# Williams AFB ST12 Containment Concerns

Fuel Release Area Conceptual Model at maximum depth to water table

## LSZ Benzene Concentrations Jan 2008

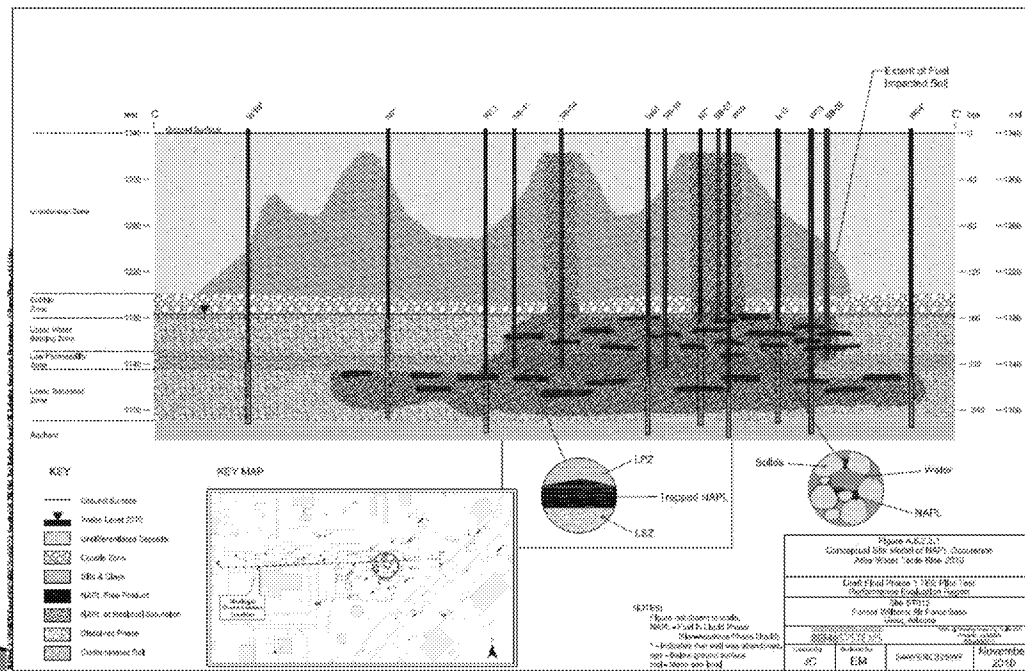
This is dissolved phase benzene before TEE Pilot operation began.  
5000 ppb contour is very small area of the site as of Jan 2008 AF has always described the plume as "stable": Did it spread just with the rising water table, or was this an underrepresentation of the actual site conditions?

## LSZ Benzene Concentrations Nov 2010

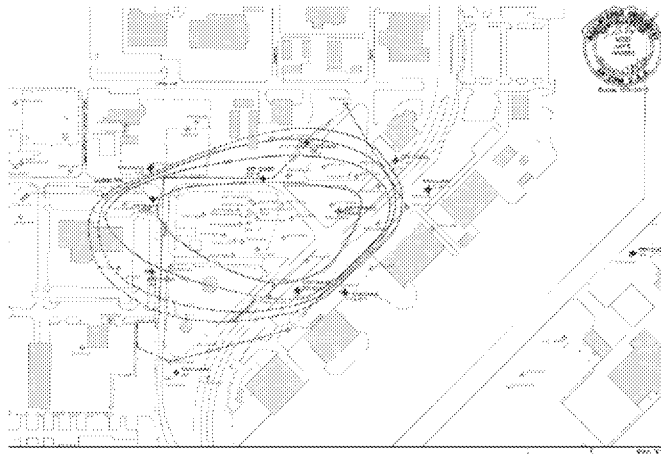
: Loss of containment was a concern during TEE because extraction pumps kept going down and weren't repaired/replaced while pilot was operating; steam injection operating without full containment.

## LSZ Benzene Concentrations Nov 2011

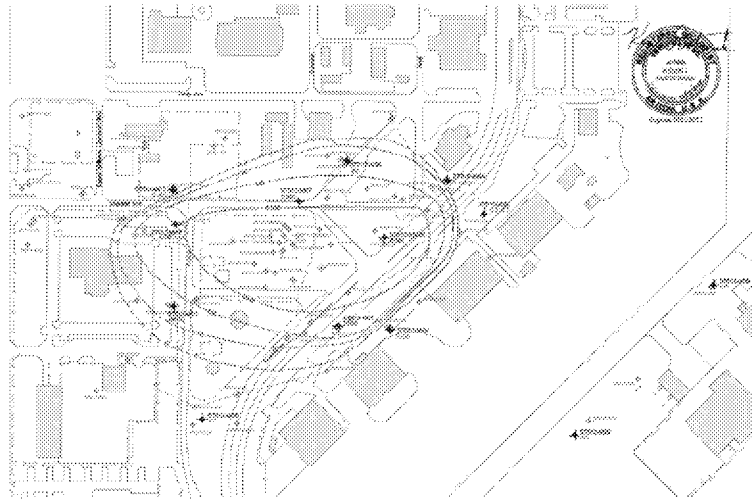
Plume continues to spread now within more highly transmissive Cobble Zone

## **LSZ Benzene Concentrations Nov 2012**

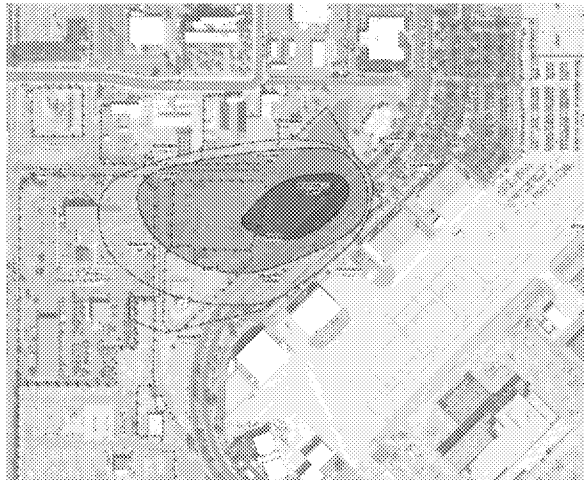
Loss of containment concern acknowledged by AF, as water table now within more transmissive cobble zone. AF implements Containment Study to contain until full scale SEE is implemented  
Dissolved plume appears to be moving eastward

## LSZ Benzene Concentrations Nov 2013

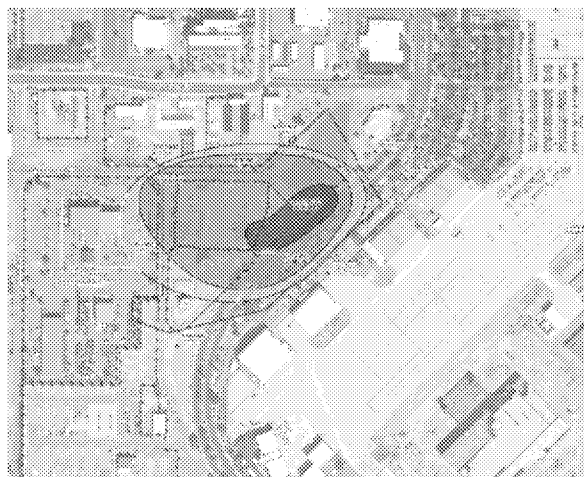
Dissolved phase Benzene as of RODA Signature: These contours are inconsistent with the figure from the RODA (see next slide): The 5000 ppb contour below is shown in dark pink Why is dissolved phase plume smaller here than in the RODA?

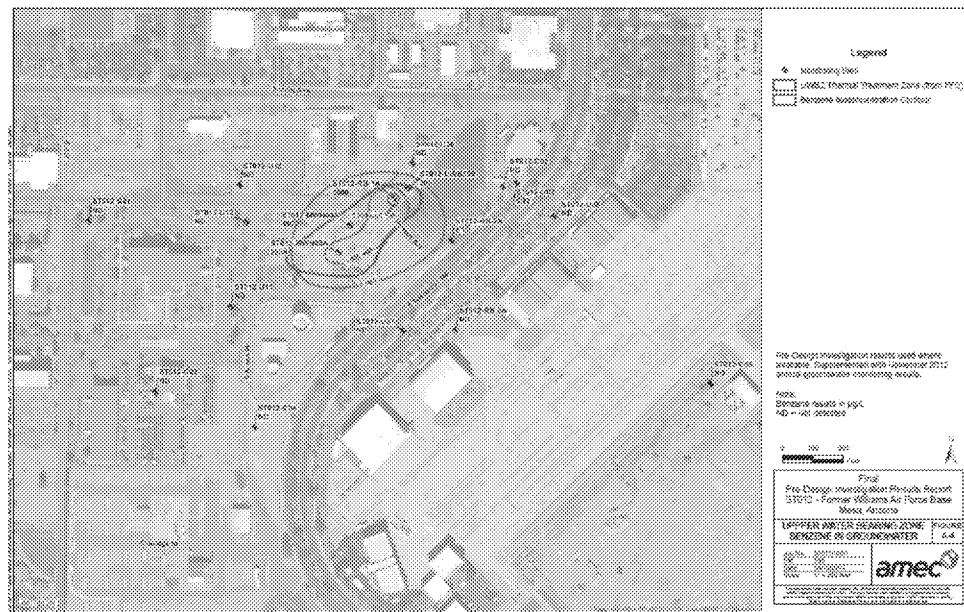
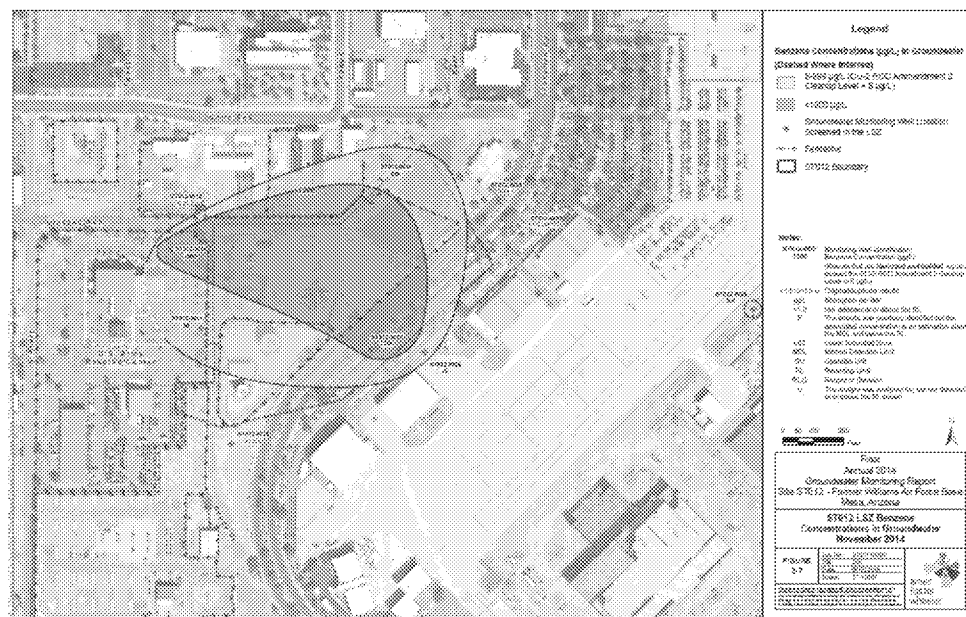
2014 Annual groundwater monitoring report – November 2014 1 month after initiation of SEE – note where 5000 ppb benzene concentration was is now 1000 ppb benzene concentration. Where did all of the benzene go? Is it volatilizing?

**Conceptual model of LNAPL distribution  
(view from southeast)**

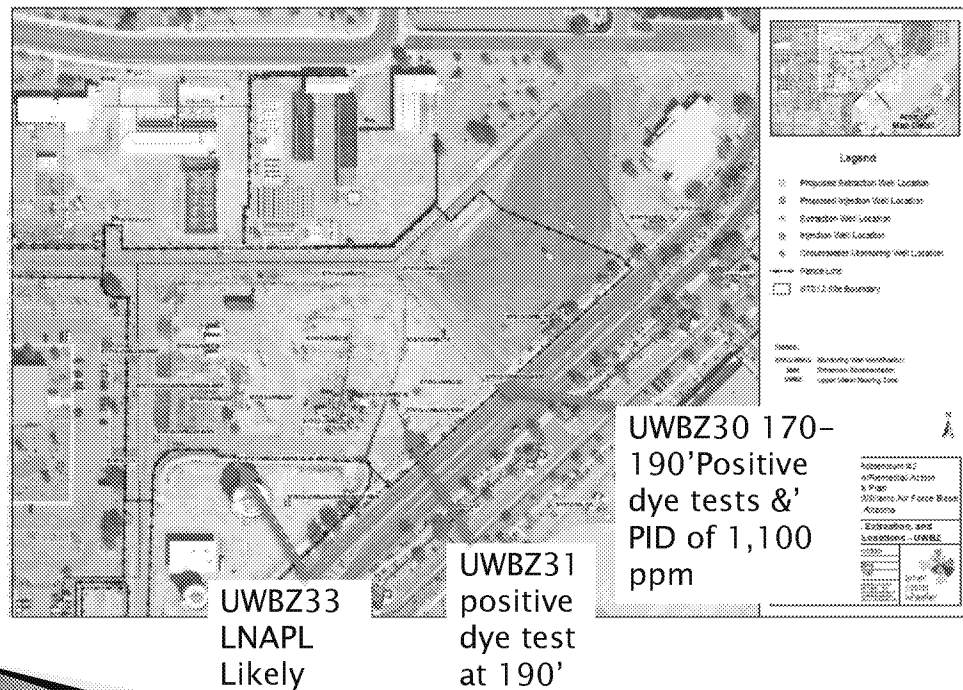
**LNAPL in Upper Water Bearing Zone** – preliminary reconnaissance data:  
Had SEE been extended to the roadway, in UWBZ, these would have already been removed. These locations are all accessible to SEE

**Lower Saturated Zone – Preliminary reconnaissance data:** While SEE was operating, LNAPL from these areas was passively recovered in adjacent monitoring wells W37, W30 and W11
